METROPOLITAN GOVERNMENT OF NASHVILLE AND DAVIDSON COUNTY

STAFF RECOMMENDATION 1404 North 14th Street February 19, 2020

Application: Violation/Show Cause; New Construction-Addition
District: Eastwood Neighborhood Conservation Zoning Overlay
Council District: 06
Map and Parcel Number: 07214017500
Applicant: Daniel Reeder
Project Lead: paul.hoffman@nashville.gov

Figure 1. 1404 North 14th Street

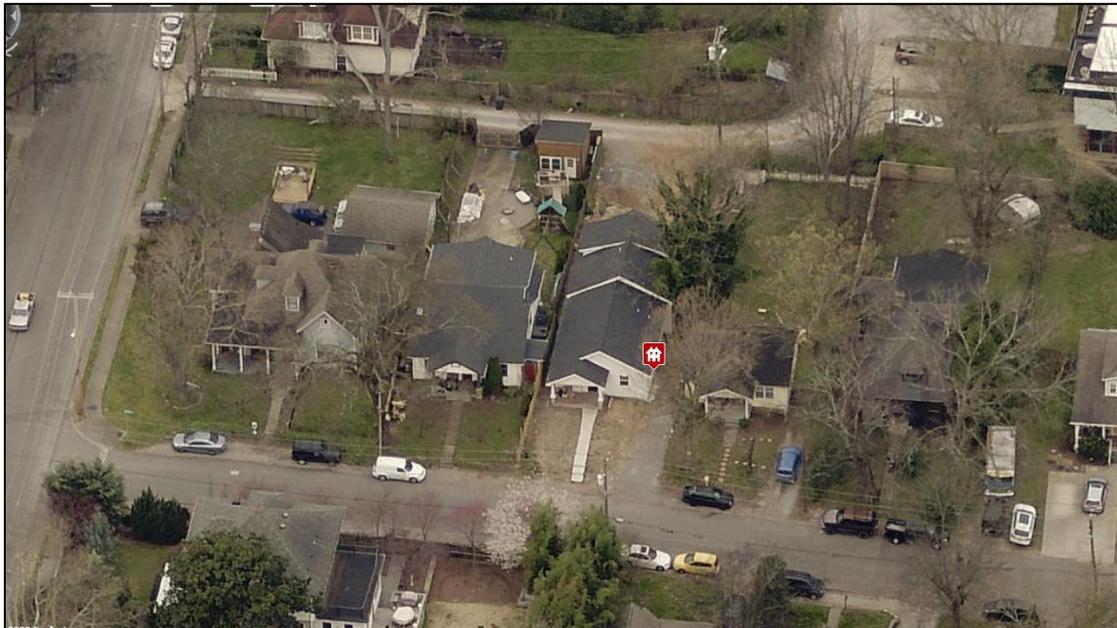
Background: Staff has ordered a Show Cause hearing for an addition to 1404 North Fourteenth Street. MHZC approved the addition in December 2017, and staff issued Preservation Permit 2017-077941 for the project. In November 2018 the applicant applied to the Commission for the addition to go taller than originally permitted, at a total of two feet (2') taller than the ridge of the house. The current violation is that the addition was built with a different roof form than originally drawn, has vinyl windows that were not approved by staff, and has embossed siding instead of smooth-faced.

Figures 2-3: Addition's roof as approved with a clipped gable, and the revised version as built, with front-facing gable.

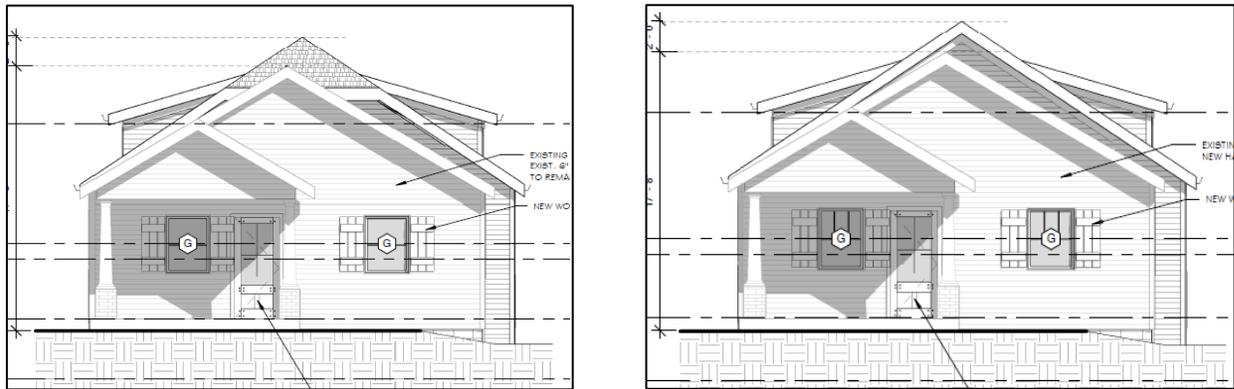
Roof form: The rear addition was approved with a clipped gable at the front, masking the two feet (2') additional height. As built, the addition has a gabled form without the clip.

Although the addition's roof was not built as permitted, the gabled roof form is a traditional one on historic buildings. The increased height above the existing ridge is minimal. At thirty-eight feet (38') back from the front of the house, its visibility is minimal from the street. In addition, the gable of the addition is offset from the historic gable, making a clipped roof awkward. For these reasons, staff recommends approval of the gabled roof as built.

Staff recommends approval of a revision to the permit to accommodate the roof as constructed. Staff recommends disapproval of the unpermitted siding and windows, and that the siding and windows be replaced with staff-approved materials within thirty days (30 days) of the Commission's decision.
